根據《城市規劃條例》(第131章)
第16條遞交的許可申請

For Official Use Only 請勿填寫此欄	Application No. 申請編號	A/H21/157
	Date Received 收到日期	- 1 JUN 2022

Proposed Minor Relaxation of Building Height Restriction for Permitted Residential Use

Request of Deferment for
Application under Section 16 of the Town Planning Ordinance for
Proposed Minor Relaxation of Building Height Restriction for
Permitted Residential Development at
at Inland Lots No. 7372 (Part), 7743, 7756 & EXT. and 7856 and
Adjoining Government Land
at 992-998 King's Road and 2-16 Mount Parker Road, Quarry Bay, Hong Kong

Photomontage of the Proposed Development - Viewpoint 2 : Viewed from King's Road (West)

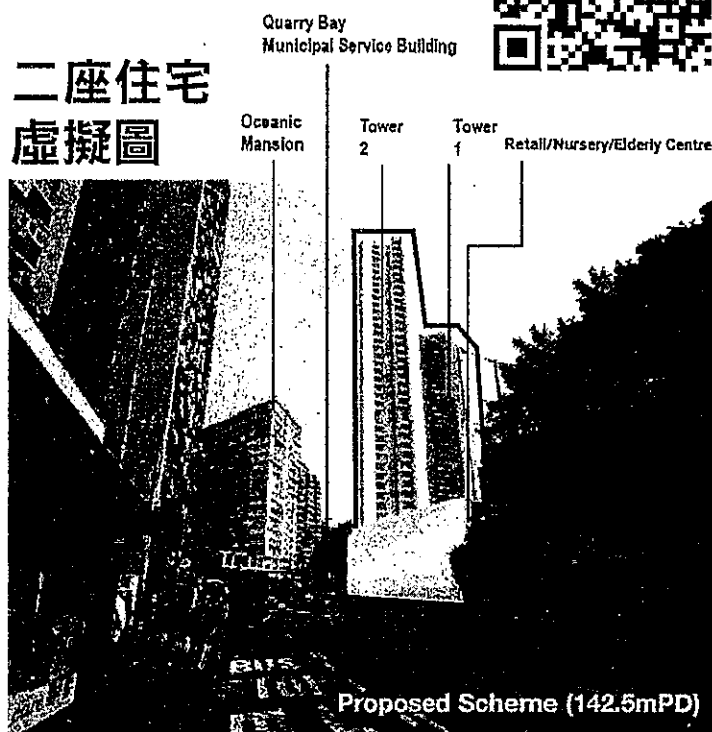
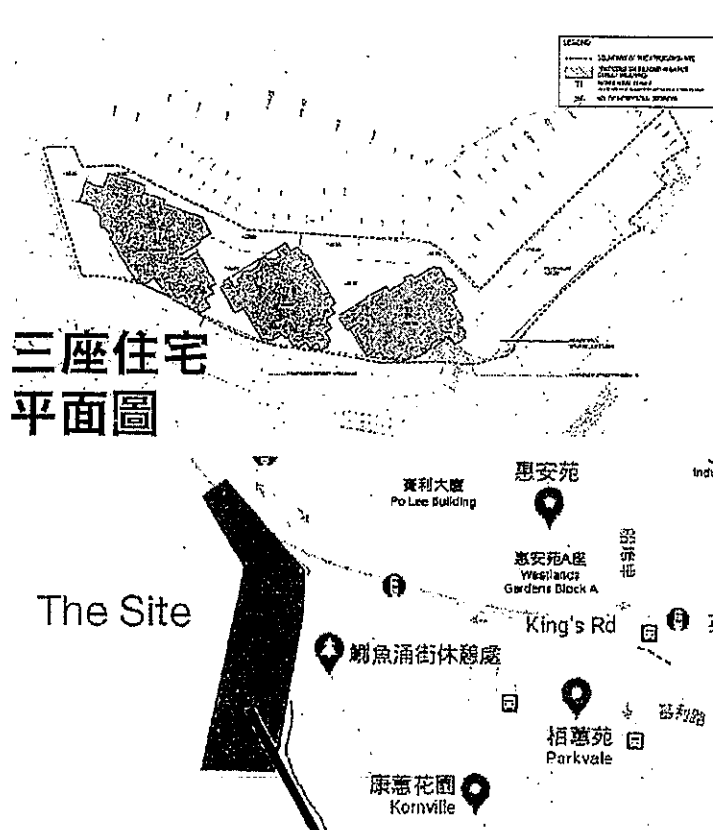
建築再次申請放寬高度至 142.5 米反映民意(申請編號: A/H21/157)

今年 6 月 10 日本辦事處又再次收到 貴會通知,指該建築再次申請增高,由 120 米申請增至 142.5 米高(申請編號: A/H21/157),於是本辦事處隨即於柏架山區內開設多個街站讓市民了解該擬議發展計劃,並以宣傳單張及網上問卷、FACEBOOK、微信等社交媒體收集市民的意見。截至 2022 年 6 月 30 日止,收集到數百份市民的反對簽名及網上問卷約超過百分之九十市民的反對意見,大部份市民仍然對計劃的社區配套、停車位增加及環境問題表示擔憂,以下詳情:

一、根據 貴會提供的申請資料顯示,該擬議發展計劃帶來接近 600 伙的住戶及私家車泊車位 209 個和 7 個電單車泊車位,另有 8 個貨車泊位,合共 224 個泊車位,比上一次申請還要多出約 80 多個車位,無疑將會為區內帶來大量人口及車輛。同時有部份居民表示柏架山道出英皇道西行線路口右邊約 20 米處,現時設有 21 條巴士線及 1 條專線小巴的車站,由於英皇道是 1 條西行的行車線,假如有停定的車輛有機會阻擋由柏架山道駛出的駕駛者視線,從而增加發生交通意外的風險,亦出現因車輛未能駛出英皇道而被迫停在柏架山道路口的情況,容易發生人車爭路的情況,導致影響附近居民出入及行山人士的安全性。
